Re: **Application by – Abbarch Architecture Inc. for Development Permit at 10600, 10700 Cambie Road and Parcel C (PID 026-669-404)**

2. Development Permit DP 11-561612

**Excerpt from the Minutes from
The Design Panel Meeting**

3. DP 11-561612 – DEVELOPMENT OF A NEW RICHMOND MINI AUTOMOBILE DEALERSHIP

2 SOUTH ELEVATION
 SCALE: 1/8" = 1'-0"

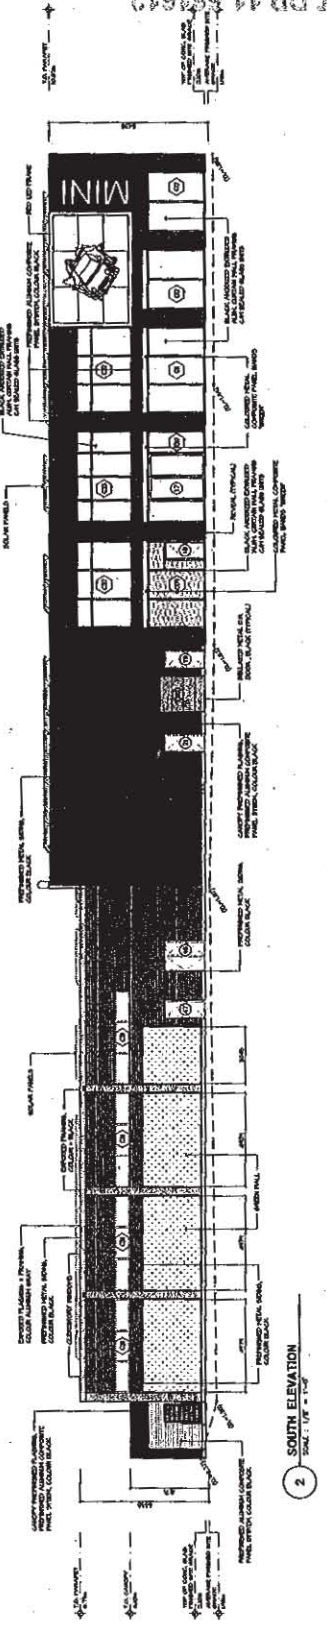
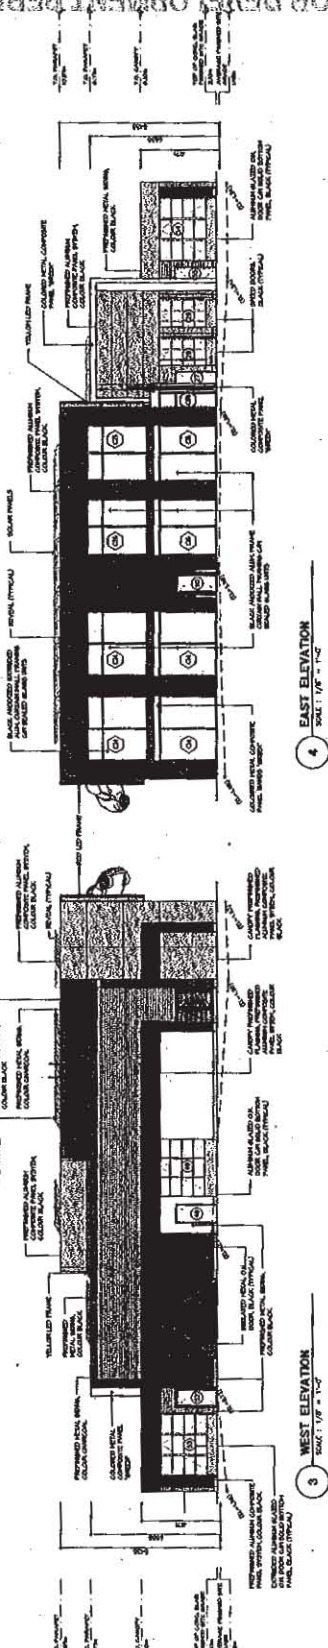
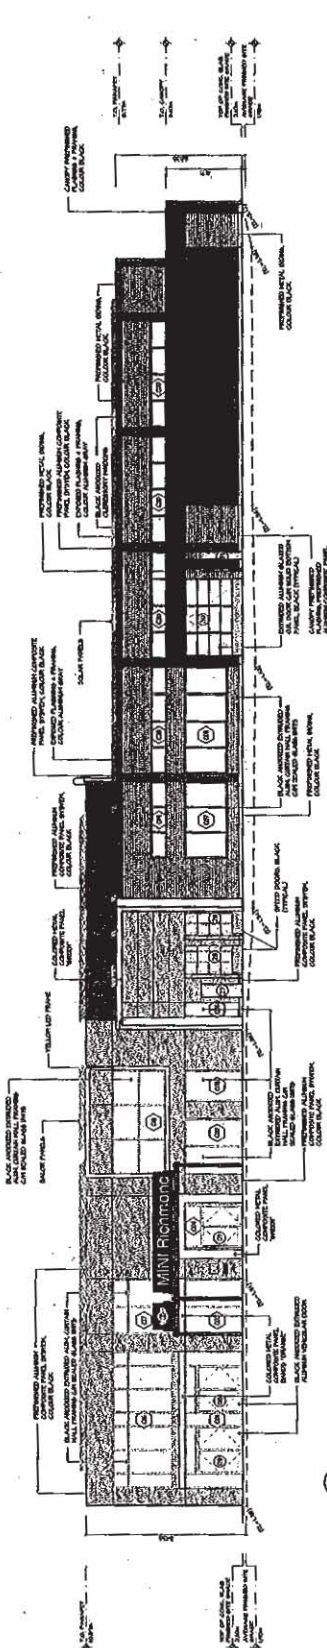
2. design development to the south[west] corner of the new building being proposed;

[ABBARCH] Comments by the Panel in regards to the design development of the sign at southwest corner of the new building being proposed have been reviewed and considered by the client and our design team. The size of the carbon fibre model on the proposed sign is predetermined to replicate a life sized mini vehicle and being shipped from Europe by the parent company. The local dealership is not able to adjust the size of the model.
